Supplement 1

Grand Gulf Nuclear Station

Evacuation Time Estimate

Figure E-6. Parks, Camps and Correctional Facilities within the GGNS EPZ

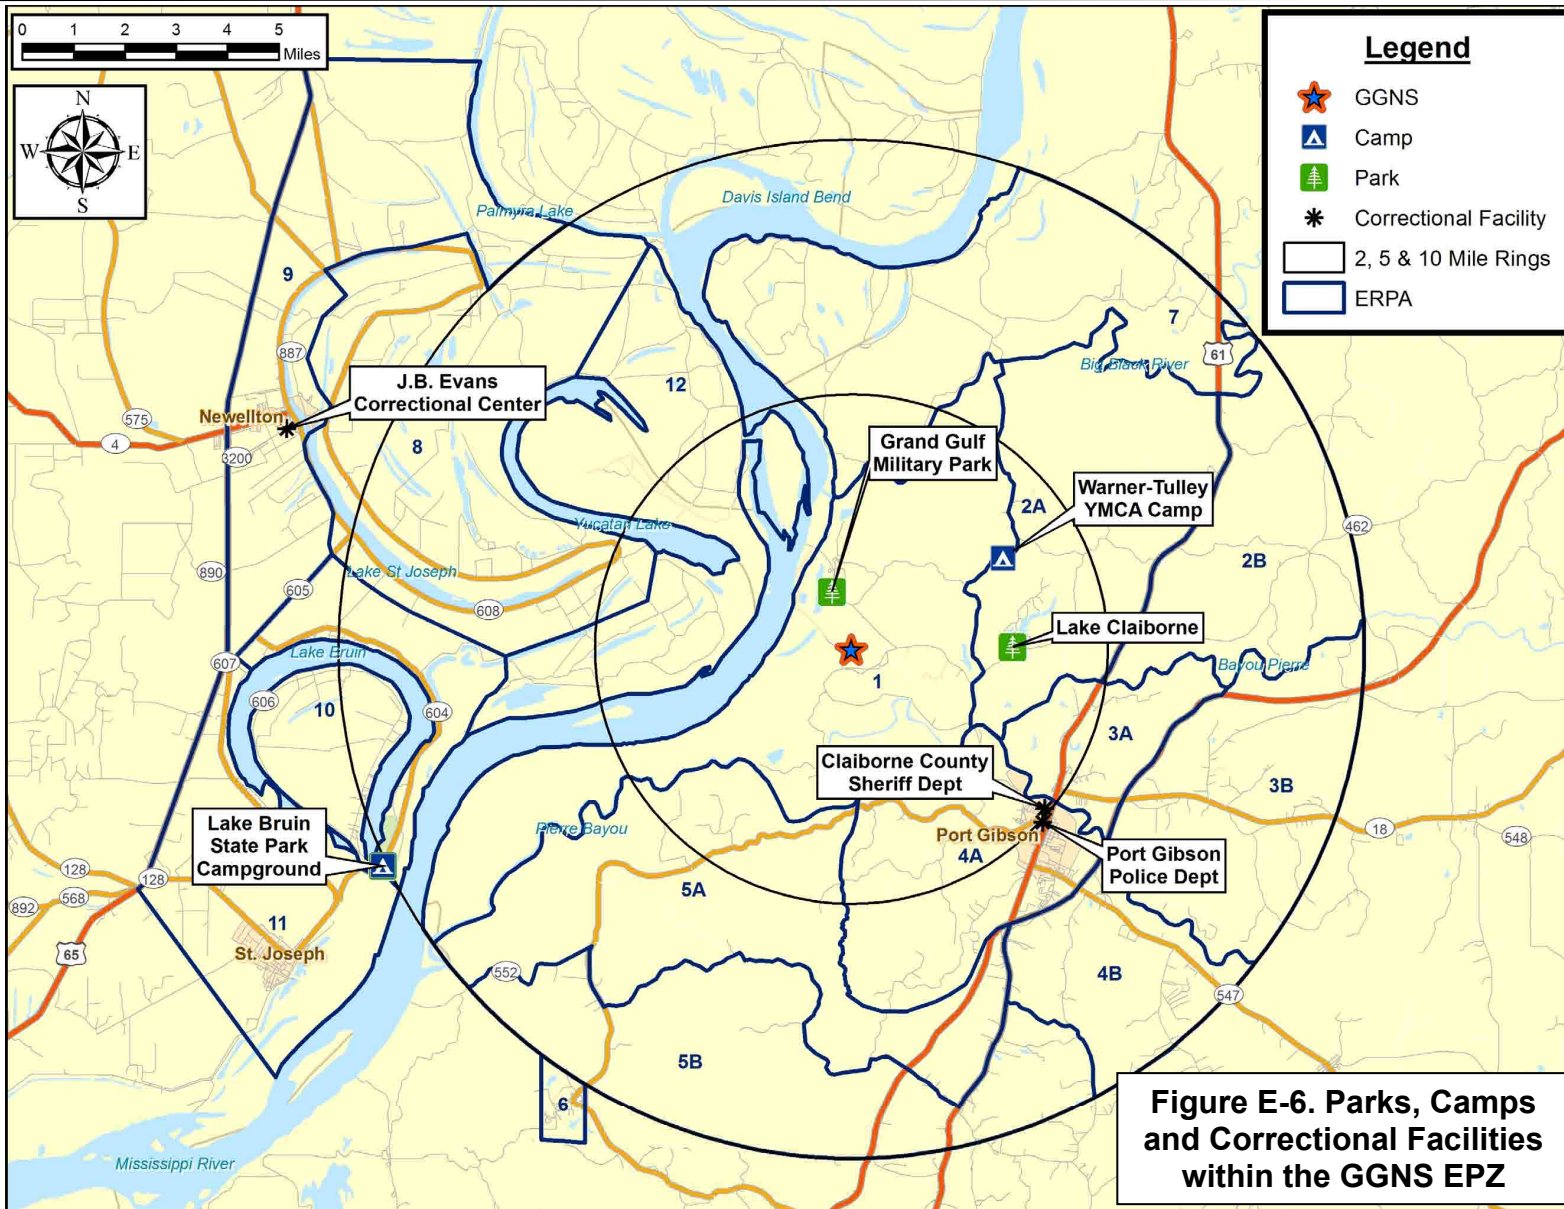
- Add “Figure E-6. Parks, Camps and Correctional Facilities within the GGNS EPZ.” See enclosed Figure E-6.
